September 24, 2018

RE: NUREG-2224 High Burnup Storage and Transport Draft Comments from Donna Gilmore,
Docket NRC-2018-0066

Figure 20 Cladding Outer Surface Oxide Layer Thickness versus Rod Average Burnup (Gigawatt days/ton of uranium). NWTRB 2010

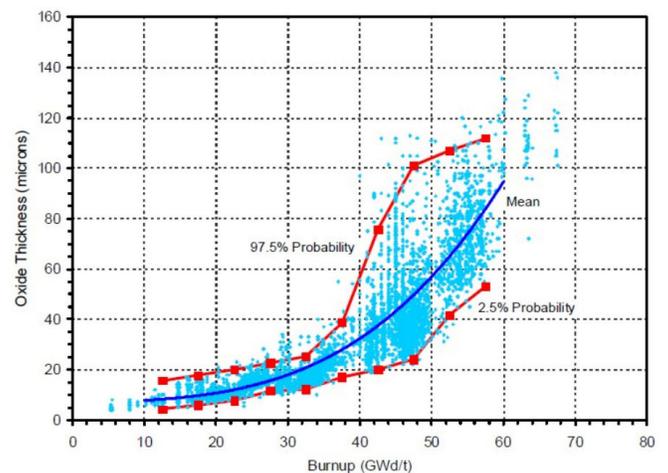
In the Nuclear Waste Technical Review Board (NWTRB) 2010 report regarding the *Technical Basis for Extended Storage of Used Fuel for Storage and Transport*,¹ it references over 4,400 measurements from commercial fuel-rods taken from reactors around the world (Figure 20). The data shows zirconium oxides and zirconium hydrides are created in moderate and high burnup fuel, with significant increases starting at ~35 GWd/MTU. There is a direct correlation with oxides and hydrides. See NWTRB report for the Chart showing the hydrides. Zirconium metal hydrides cause damage to the cladding, making it more brittle, thinner, and increases

hydrogen gas explosion risks if fuel rods are exposed to air (whether in pool or dry storage). Zirconium hydrides ignite at only 270 degrees Celsius.

The NRC continues to ignore this operating data. I have asked in numerous NRC technical meetings over the years why the NRC ignores this data, including at the one public meeting held on NUREG-2224 (September 6, 2018). Normally the NRC will respond with some type of answer to my questions. When I ask about this operating data, they don't even do that. They change the subject. I would like a response as to why the NRC ignores this data.

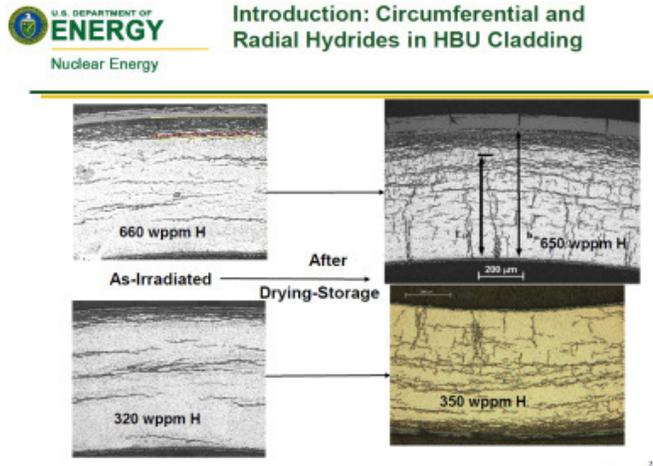
What evidence was used to redefine high burnup fuel from > 40 GWd/MTU to >45 GWd/MTU when there is evidence showing damage starting above 33 GWd/MTU? The scope of the high burnup NUREG-2224 should evaluate moderate burnup fuel, also.

Why is the above referenced experimental data being discounted?
